**A RESOLUTION APPROVING THE CONDITIONAL USE PERMIT
FOR THE CHAPEL HILL-CARRBORO HIGH SCHOOL #3
LOCATED AT 201 ROCK HAVEN ROAD
Resolution No. 140/2004-05**

STAFF REPORT

PROJECT: Carrboro High School #3

PURPOSE: To acquire a Conditional Use Permit allowing for the construction of a High School Facility with associated infrastructure and facilities on the property located at the western terminus of Rock Haven Road.

OVERALL
SITE
PLAN

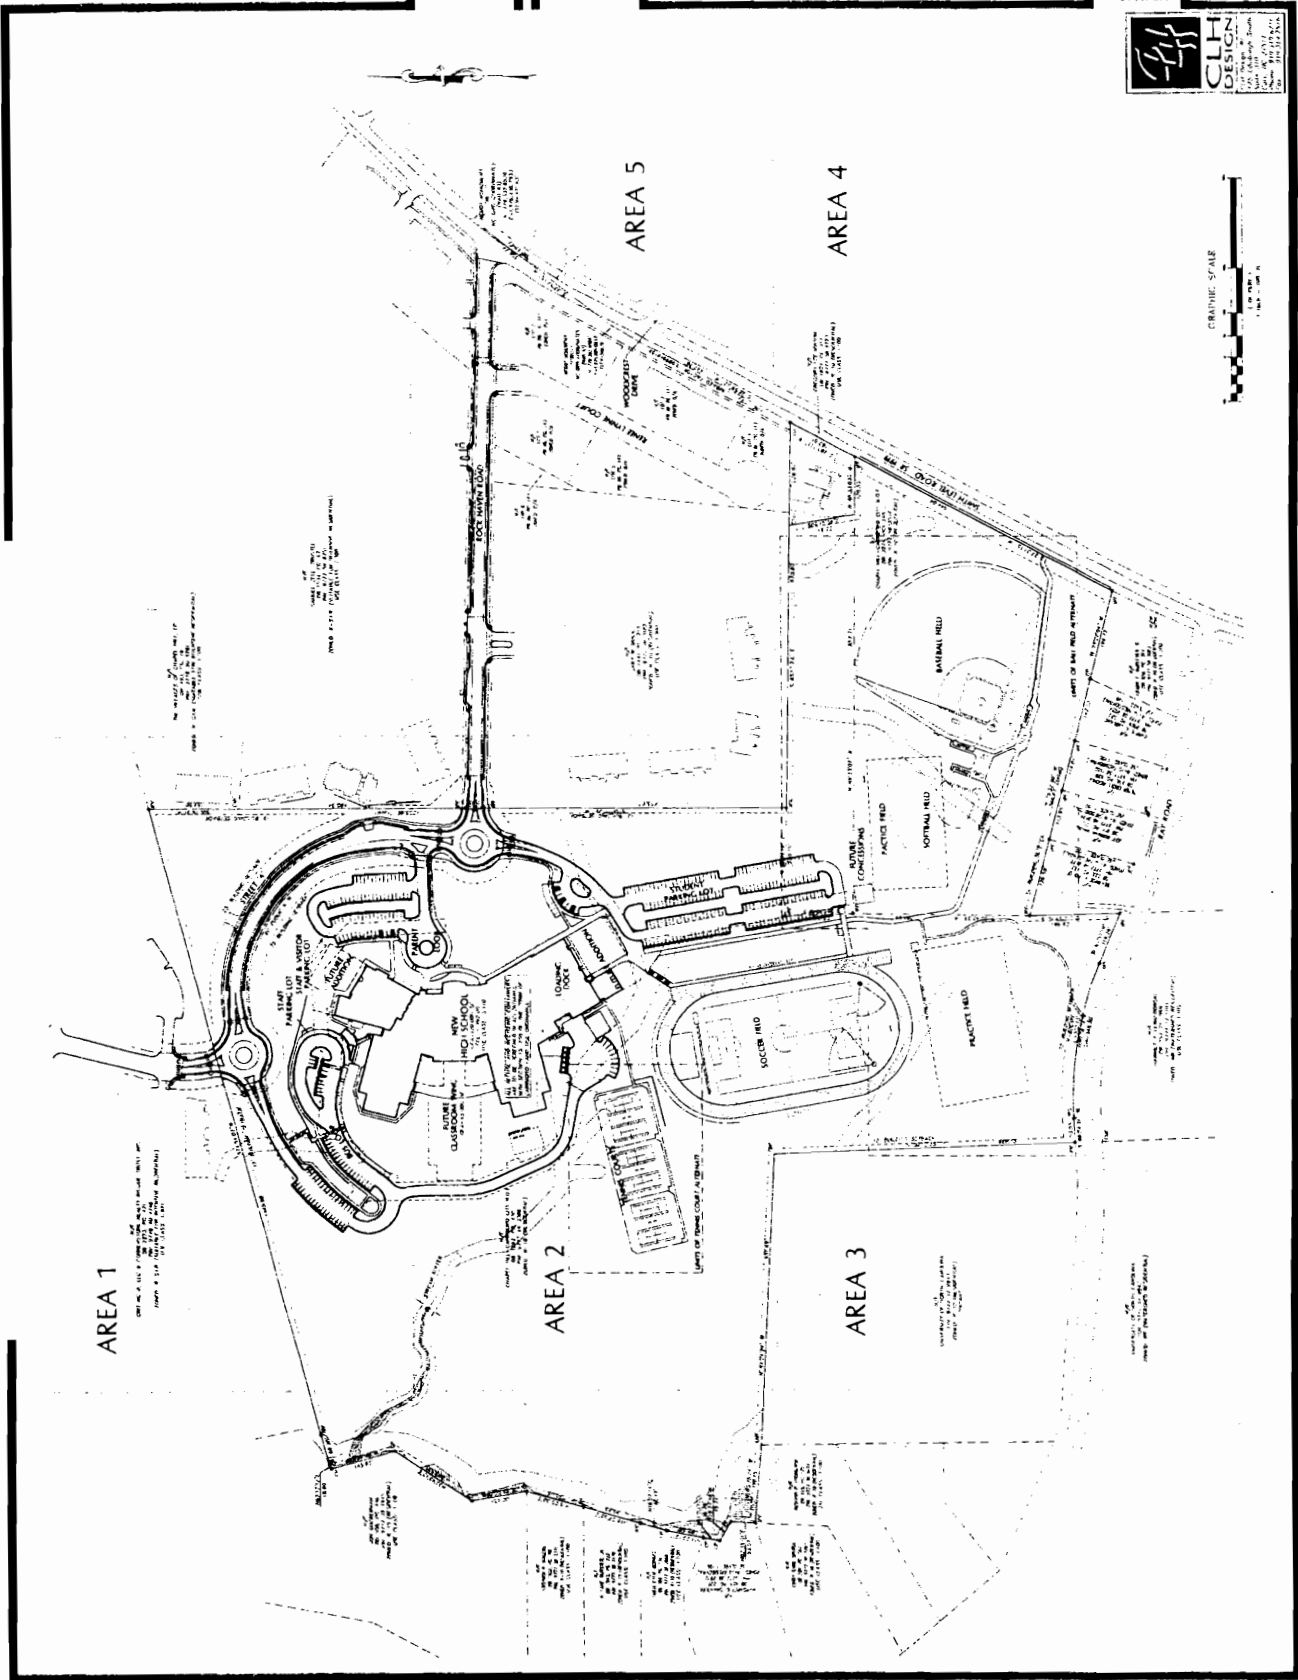
- That additional plantings be added to the Type “B” screen adjacent to the southern parking lot prior to construction plan approval.
- That the Type “C” screen along the northeastern property line be re-labeled as a Type “B” screen prior to construction plan approval.

- That the Chapel Hill Transit bus stop turn-out detail be modified to the Town of Chapel Hill’s bus stop detail (ST-8) prior to construction plan approval.

- That the waterline located under the “Future Addition” on the northeast section of the building be relocated out of this area prior to construction plan approval.
- That the waterline and sewer crossing the landscaped area on the southern tip of the northwestern parking lot be relocated into the paved area prior to construction plan approval.

Recommended Lanes and Storage for Chapel Hill-Carborro High School (SC-2004-043)

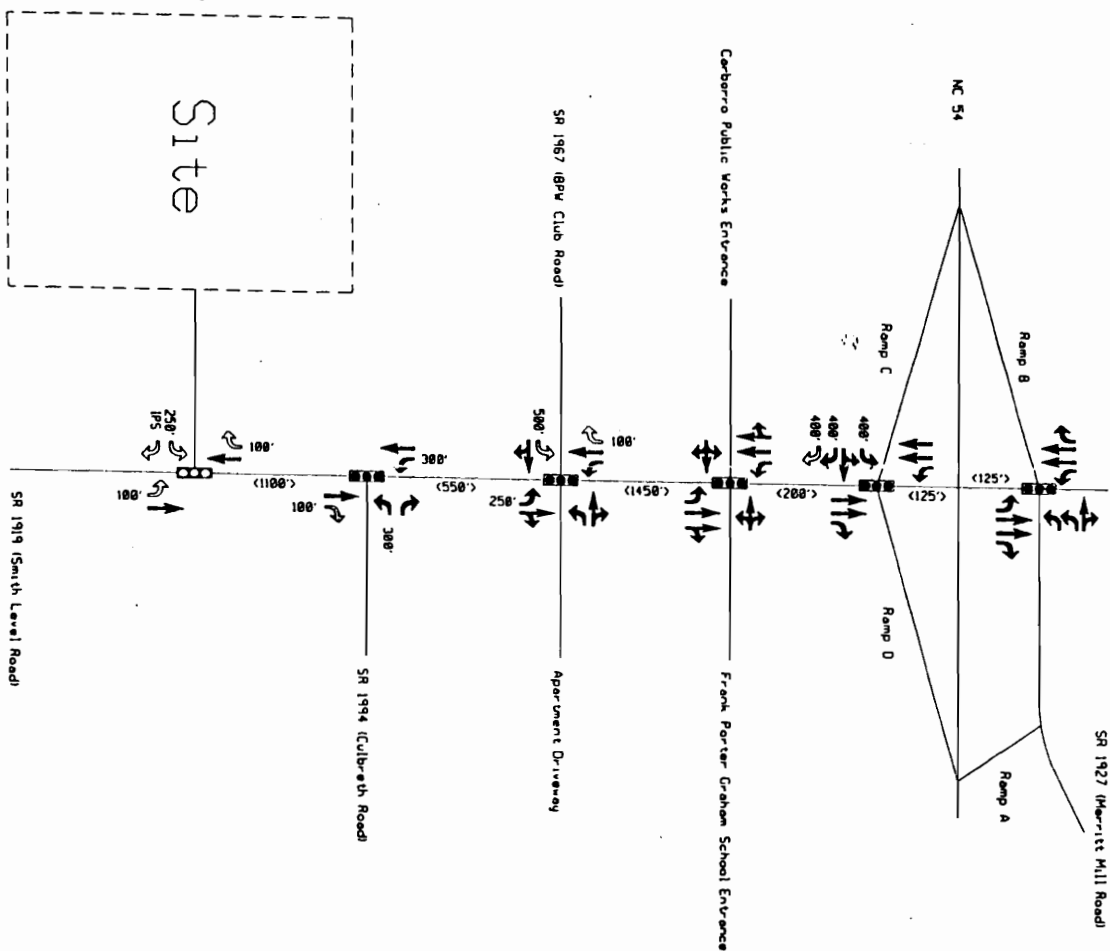
- We recommend extending the exclusive left-turn lane to provide 300 feet (minimum) of full storage and appropriate transitional taper.

- We recommend providing an exclusive left-turn lane with 100 feet (minimum) of full storage and appropriate deceleration taper. However, based on the TIA 2013 (Phase II) build-out year traffic volumes, the exclusive left-turn lane should provide 500 feet (minimum) of full storage and appropriate deceleration taper to accommodate background volumes. =

- To accommodate the anticipated site generated trips on this approach, we recommend providing dual right-turn lanes, by constructing an additional right-turn lane. Both lanes should provide 400 feet (minimum) of full storage and appropriate transitional taper.
- No left-turn improvements are necessary on this approach at this time to mitigate site-generated traffic. However, based on the TIA 2013 (Phase II) build-out year traffic volumes, the exclusive left-turn lane should be extended to provide 400 feet (minimum) of full storage and appropriate transitional taper.
